UNITED STATES PATENT AND TRADEMARK OFFICE

| APPLICATION NO. | FILING DATE | FIRST NAMED INVENTOR | ATTORNEY DOCKET NO. | CONFIRMATION NO. |
|--|-------------|----------------------|---------------------|------------------|
| 10/762,683 | 01/20/2004 | Thomas E. Broome | 1001.1720101 | 5270 |

DETAILED ACTION***Claim Rejections - 35 USC § 102***

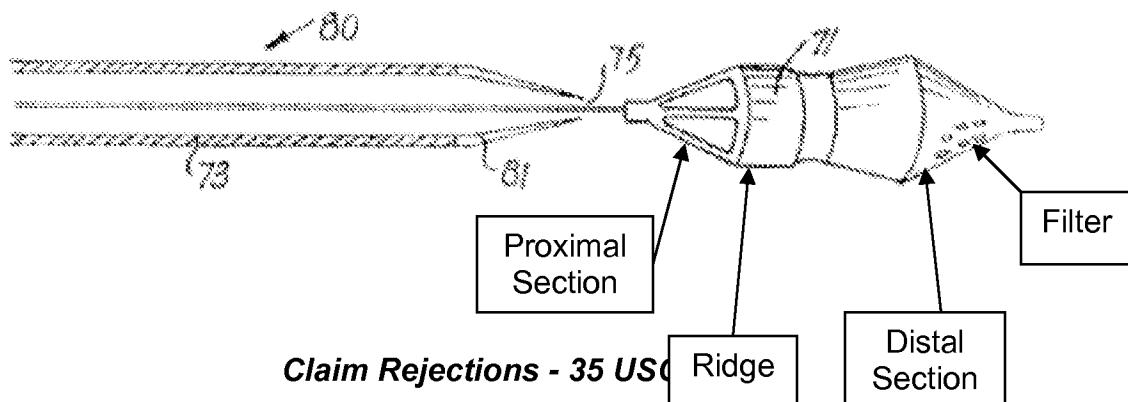
2. **Claims 1, 4, 6, 8-11, 22, 25 and 27-36 are rejected under 35 U.S.C. 102(b) as being anticipated by Vale et al. (2002/0058963).** Vale et al. disclose a medical device (see figures 27-30) comprising an elongated tubular member (73) having a proximal and distal (81) segment, a dilator tip (for example, see annotated figure 27 below), a filter portion, and a guidewire (see figure 27). The distal segment expands radially as the proximal section of the dilator tip passes there through because the outer diameter of the dilator tip catheter is greater than the inner diameter of the distal segment of the elongated tubular member (see figure 29).
